**DEPARTMENT OF COMMUNITY DEVELOPMENT  
Design Review Committee Agenda**

**COA-2015-00009 – LJP Properties, LLC (Page Audi)**

## **COA-2015-00009**

**Project:** Audi Car Dealership (architecture only)

2 EAST ELEVATION  
 A300V2 Scale: 1/32" = 1'-0"

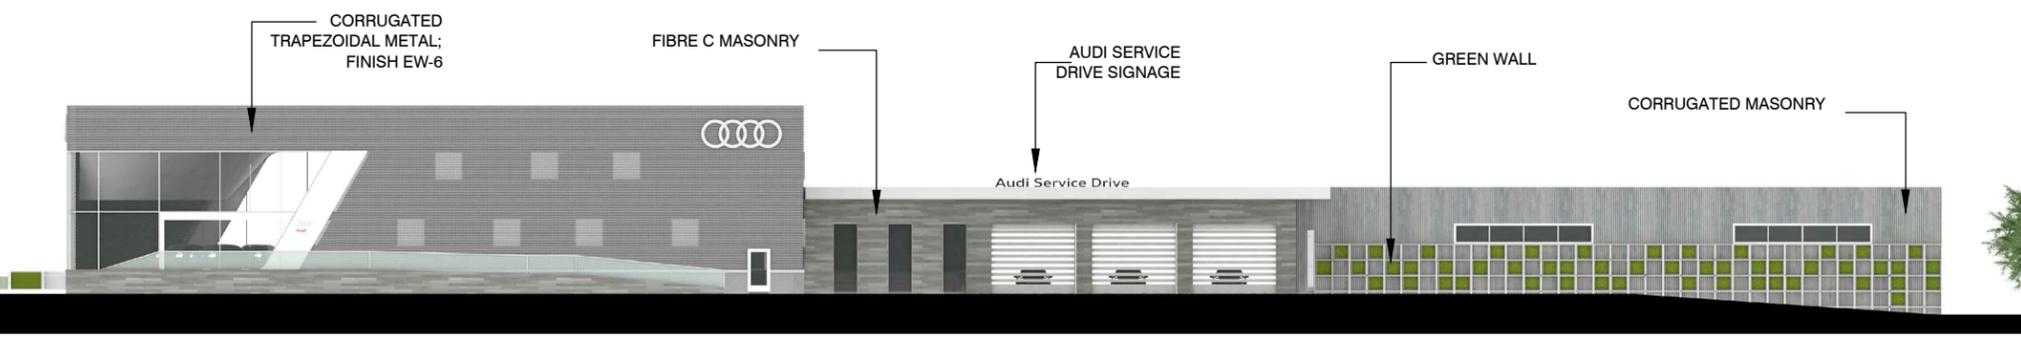
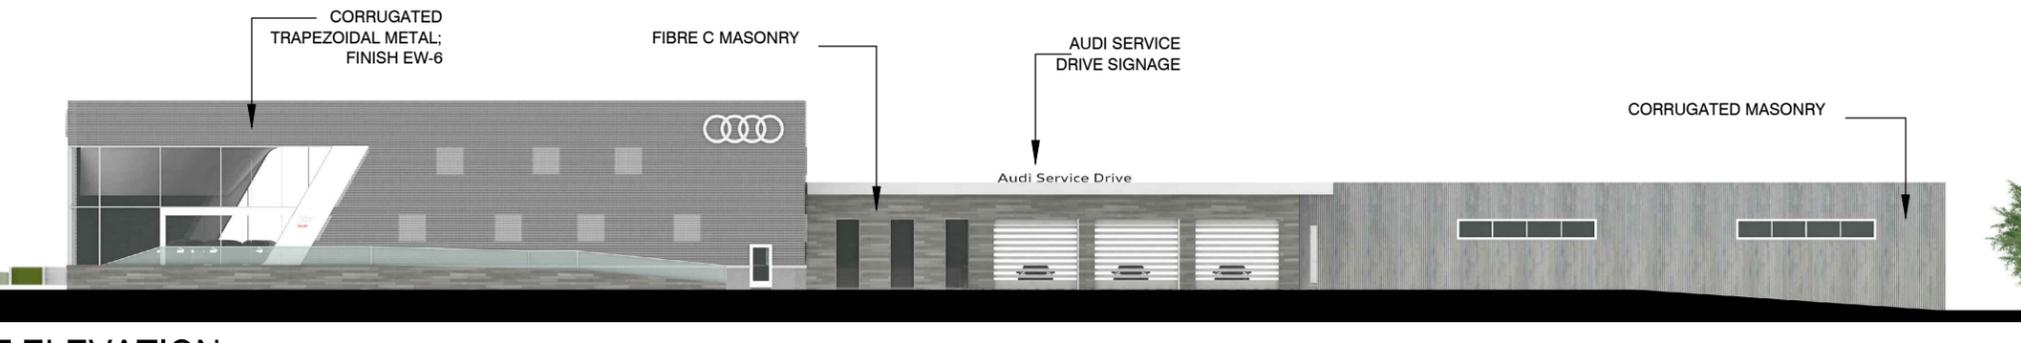
*Option A* keeps the east façade (facing the boulevard entrance) with the glass corner towards Broad Street but reduces the long metal facade from 148' to 122' (17.5% reduction). This increases the masonry area adjacent to the service area and provides an additional break in the massing of the façade. Open area “windows” are enlarged to soften the metal. The architect has

indicated that there is a stone base below the main showroom window that wraps around the entire building. The eastern elevation (Boulevard side) is the only elevation that has metal more than 30% of the facade.

#### **1. The metal area should be limited to approximately 30% of the entire facade.**

2 EAST ELEVATION  
 A300V2 Scale: 1/32" = 1'-0"

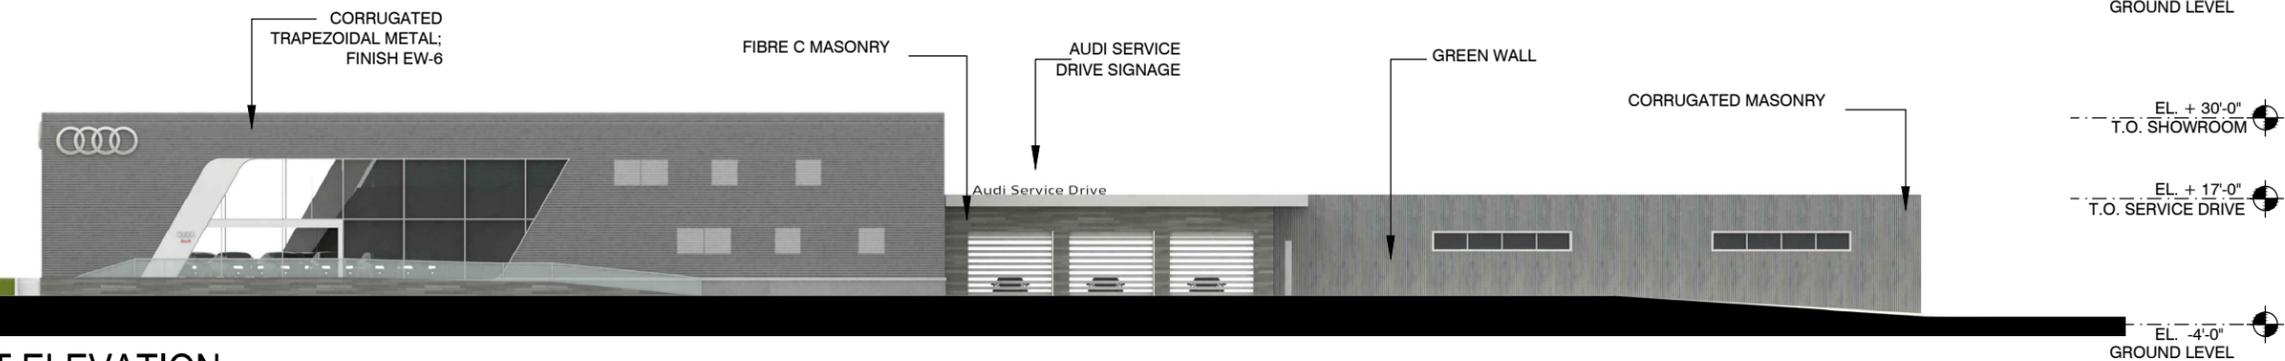
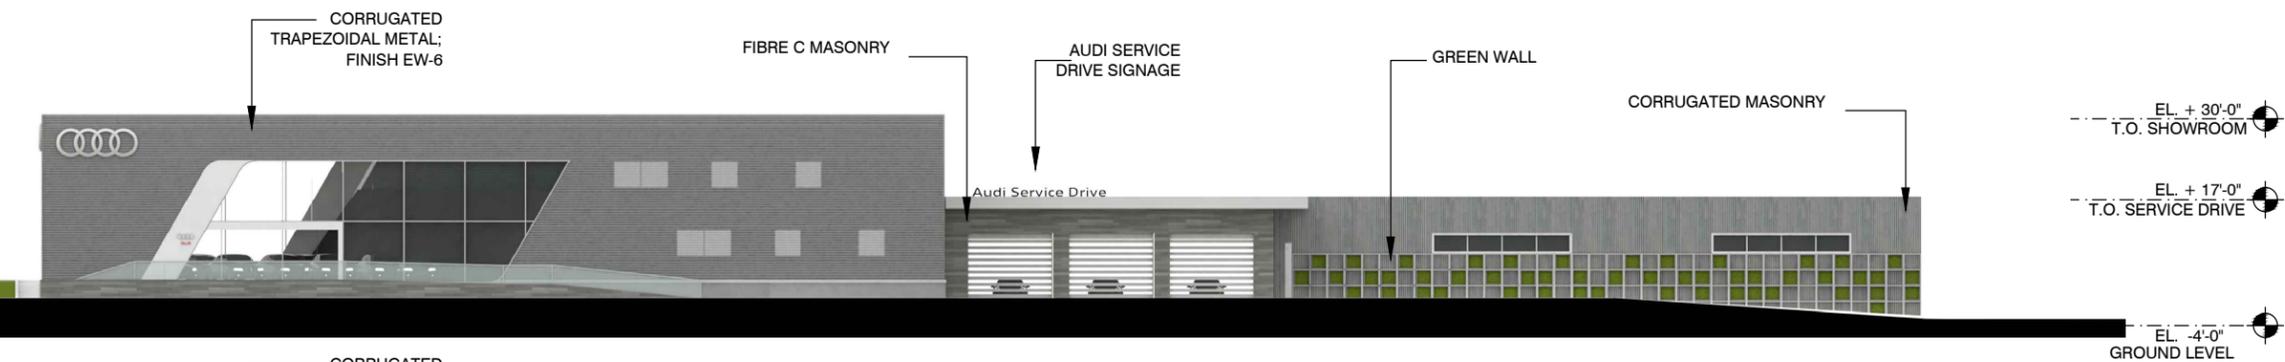
*Option B* flips the open corner to the west facade (towards Rt. 288) but keeps the length of the side elevations the same as shown at the December meeting. The east elevation (facing the boulevard entrance) and west elevation (facing towards 288) are slightly above 30% metal; and the south (Broad Street) and north (rear) are slightly less.
